Exhibit A1
Staff Report
Wilsonville Planning Division
Mercedes-Benz Inventory Storage Area

Development Review Board Panel 'A'
Quasi-Judicial Public Hearing
Amended and Adopted November 14, 2022
Added language ***bold italics underline***
Removed language ~~struck through~~

Application Nos.: DB22-0005 Mercedes-Benz Inventory Storage Area
- Stage 2 Final Plan Modification (STG222-0005)
- Site Design Review (SDR22-0005)

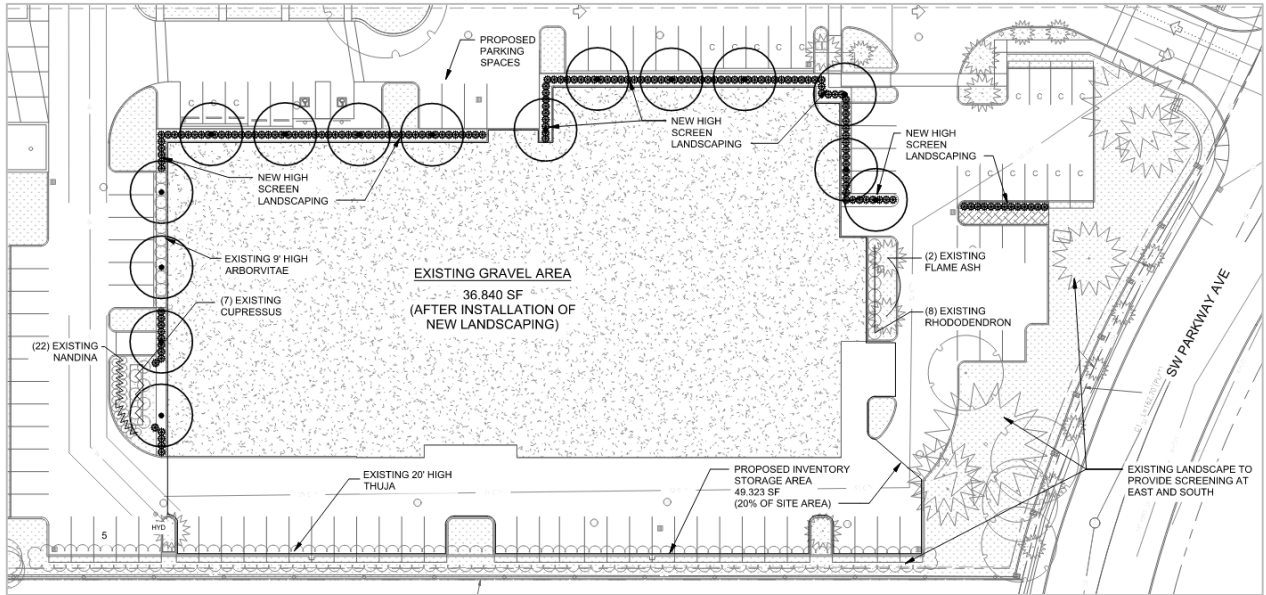
As shown in the illustration below, excerpted from the Proposed Stage 2 Landscape Plan, the applicant proposes Akebono Yoshino cherry trees planted approximately 30 feet on center on the west, north, and northeast sides of the inventory storage area. Emerald green arborvitae shrubs at least six (6) feet in height planted 32 inches on center are proposed between and under the trees to provide a continuous screen that is 95% opaque year-round. Massachusetts kinnikinnick groundcover is proposed in a small area of landscape island south of the employee parking area at the northeast corner of the inventory storage area. Existing landscaping provides the required screening on the southeast and south sides of the inventory storage area. The proposed landscaping, combined with some limited

B15. Perimeter trees in the applicant's Landscape Plan (Exhibit B2) are proposed to be 1.5-inch caliper (deciduous), which is not consistent with the 2-inch caliper requirement of this subsection. A Condition of Approval will require all trees to be a minimum of 2-inch caliper, balled and burlapped (B&B), well-branched, and typical of their type as described in Current American Association of Nurserymen (AAN) Standards.

PDB 6.	<u>Prior to Inventory Storage Area Use:</u> All trees shall be balled and burlapped and conform in grade to “American Standards for Nursery Stock” current edition. Tree size shall be a minimum of 2-inch caliper. See Finding B15.
PDB 7.	<u>Prior to Inventory Storage Area Use:</u> Plant materials shall be installed and irrigated to current industry standards and be properly staked to ensure survival. Plants that die shall be replaced in kind, within one growing season, unless appropriate substitute species are approved by the City. See Finding B21.
PDB 8.	<u>Prior to Final Inspection of Landscape Materials:</u> The applicant shall indicate water usage areas for proposed site landscaping on the Landscape Plan. See Finding B22.
